## B300 The Cut

### Traffic Cycle Measures Phase 2A

#### Stage 2 Road Safety Audit

Ref: 3631/007/B300/TLRN/2020

### **Problem Locations**

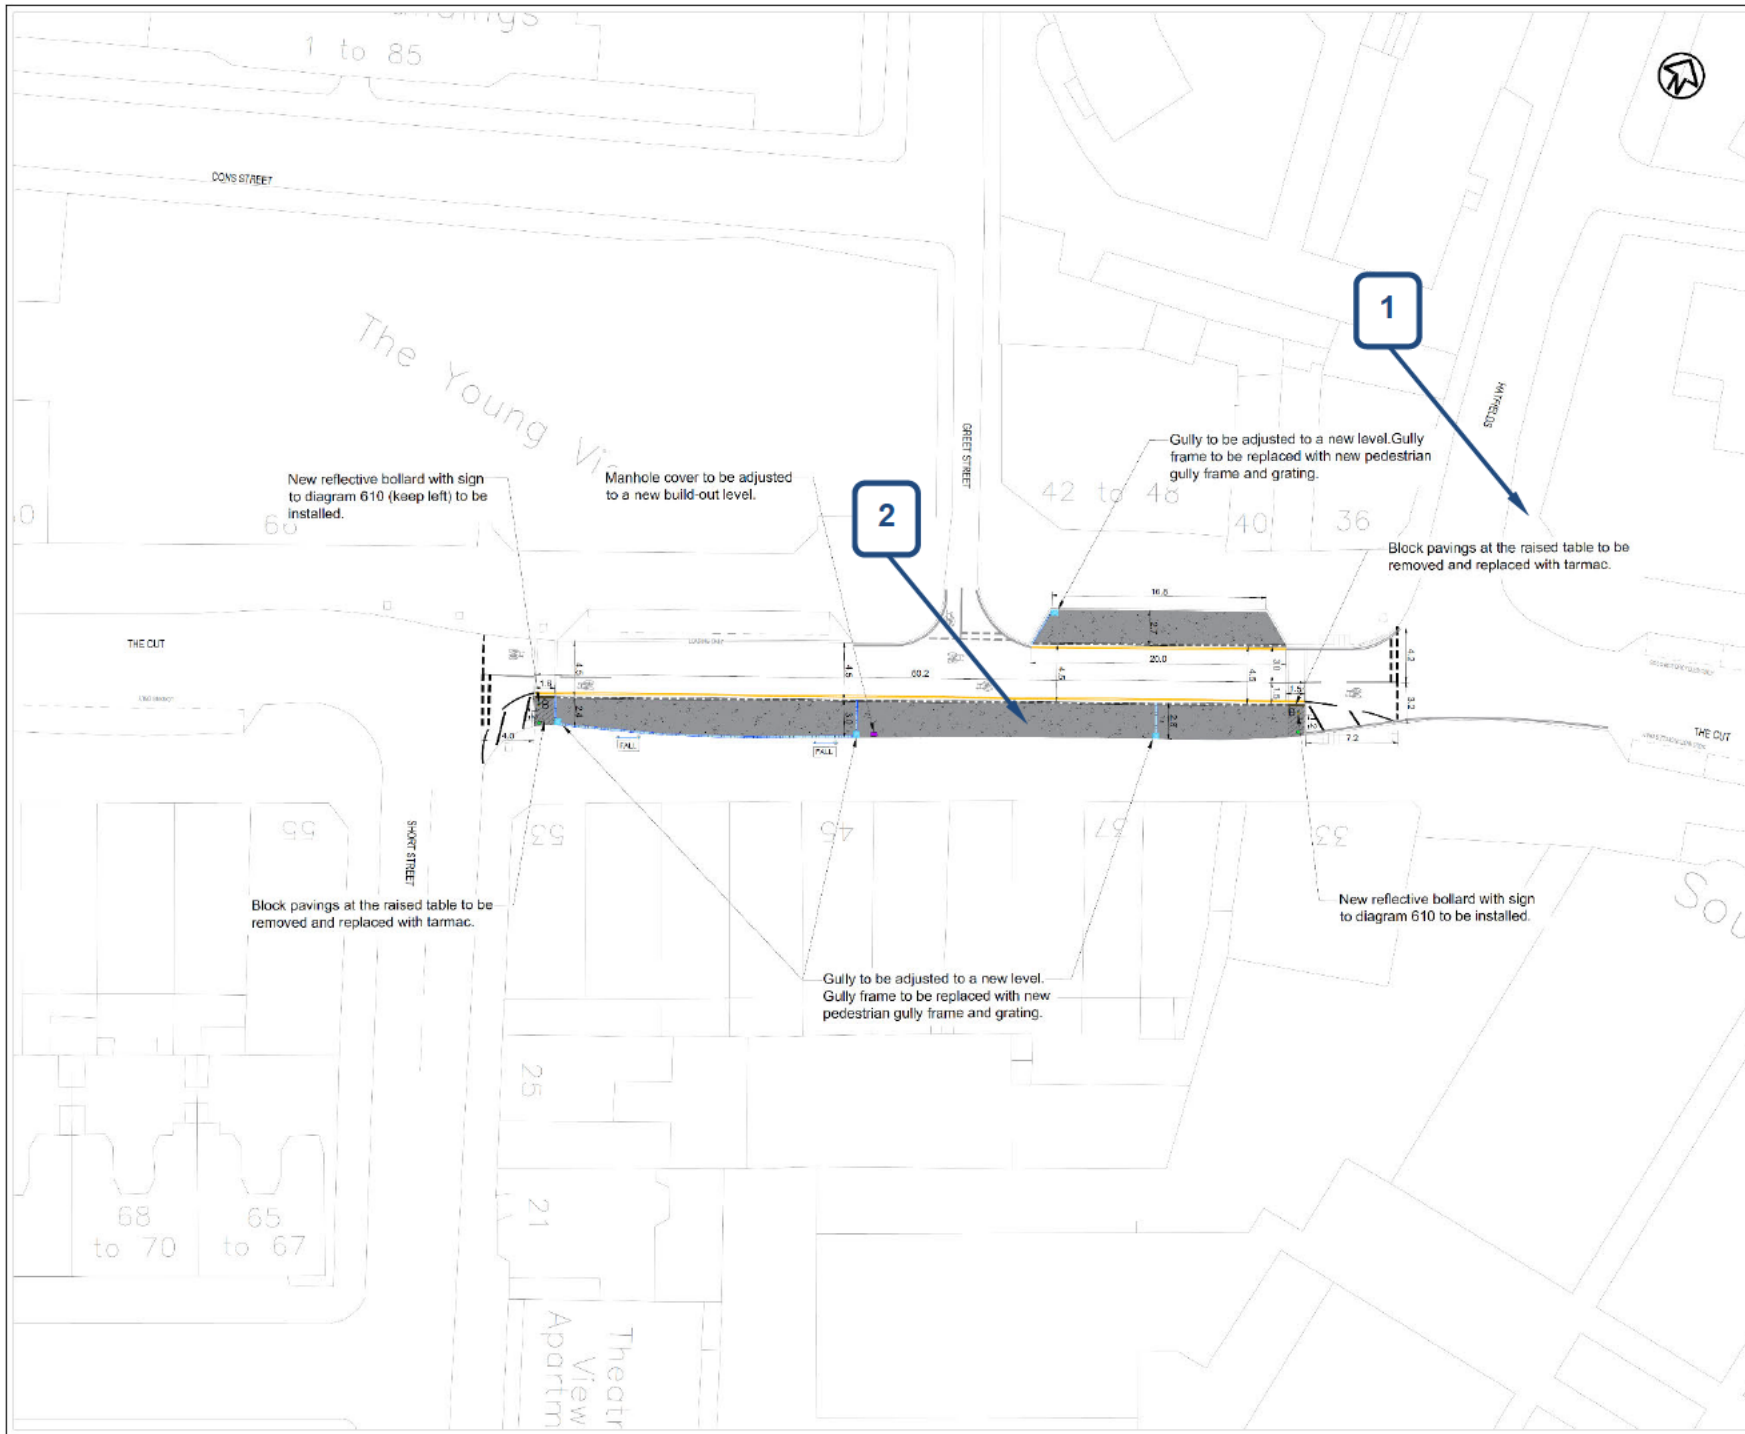
**Location:** 1 – Hatfields, southbound approach to the junction with The Cut.

The nearside 'Left Turn Only (except cycles) sign is shown to be mounted on an existing lamp column. Based on Google StreetView, there is no existing lamp column at this location. It is recommended that a suitable location is identified for the sign.

**Location:** 2 – The Cut, eastern side of the proposed footway buildout.

The proposed buildout will be on top of an existing raised table. As a result, it may fall back towards the existing footway. A channel drain is proposed on the western half of the buildout, but not along the eastern half. From the drawings, it is unclear whether water on the eastern side of the buildout could flow back towards the existing footway and pond. It is recommended that the levels on the eastern side of the buildout are assessed, and if necessary appropriate drainage provision provided.

Design Organisation Response	Accepted / Part Accepted / Rejected
Both signs have been installed on an existing lamp column in SB footway on Hatfields. Actual location in footway is a few north of where indicated in the design drawing. Location to be amended in as built drawing.	
Client Organisation Comments	
Noted. No action required. Adjustment to be reflected at as-builts

Design Organisation Response	Accepted / Part Accepted / Rejected
No topo survey information was provided for this location so assessment for drainage was based on desktop analysis of existing.	
There is existing footway drainage in the footway on the eastern side of the proposed build-out, so it is expected that surface water runoff from the build-out will find its way to this catchment area.	
Extents of proposed linear drainage to be assessed on site to determine best layout to address drainage requirements.

Agreed. Best to determine drainage layout on site.
